Project	<b>IEEE 802.16 Broadband Wireless Access Working Group</b> < <a href="http://ieee802.org/16">http://ieee802.org/16</a> >	
Title	<b>Proposed Changes to IR HARQ Bit Selection (15.3.12.3.1) for IEEE P802.16m/D1</b>	
Date Submitted	<b>2009-08-30</b>	
Source(s)	Eugene Visotsky, Fred Vook, and Bishwarup Mondal	<a href="mailto:eugenev@motorola.com">eugenev@motorola.com</a> <a href="mailto:fred.vook@motorola.com">fred.vook@motorola.com</a>
	Motorola Inc.	
Re:	Category: P802.16m/D1 comments for LB30 Area: Chapter 15.3.12 (Channel coding and HARQ)	
Abstract	This contribution examines the performance of the DL and UL bit selection schemes for DL IR transmissions and determines their performance to be virtually identical. As the UL bit selection scheme is the simpler of the two, it is proposed to support only the UL bit selection for both DL and UL IR transmissions.	
Purpose	To be discussed and adopted by TGm for the P802.16m D1 Draft.

# Proposed Changes to IR HARQ Bit Selection (15.3.12.3.1) for the IEEE P802.16m/D1

Figure 1. SE comparison of the DL and UL bit selection methods.

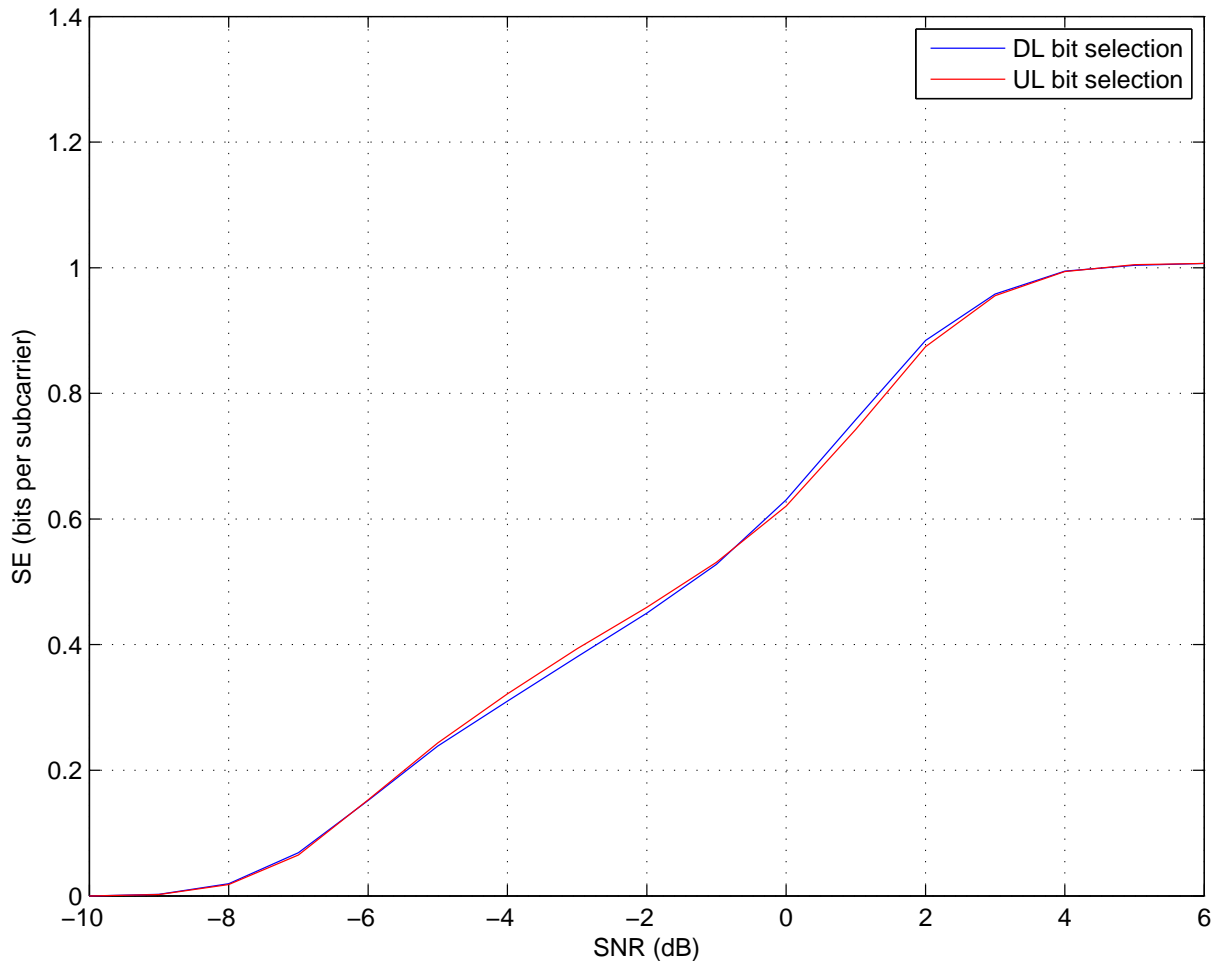
In Section 15.3.12.3.1 of P802.16m/D1, two different IR bit selection schemes for the DL and UL are defined with respect to the HARQ buffer starting position  $P_{i,k}$ . Below a performance comparison of the two schemes is shown in terms of achieved spectral efficiency with 5 HARQ transmission attempts in UMA channel conditions. A detailed simulation description is given in Table 1. Spectral efficiency versus SNR of the two schemes is shown in Figure 1. As evident from the figure, the performance of the two bit selection methods is virtually identical on the DL. As the UL method is the simpler of the two, it is then proposed to unify the DL and UL bit selection methods and to support only the current UL bit selection method for both DL and UL transmissions. Proposed text changes for implementing this proposal in P802.16m/D1 are outlined in the next section.
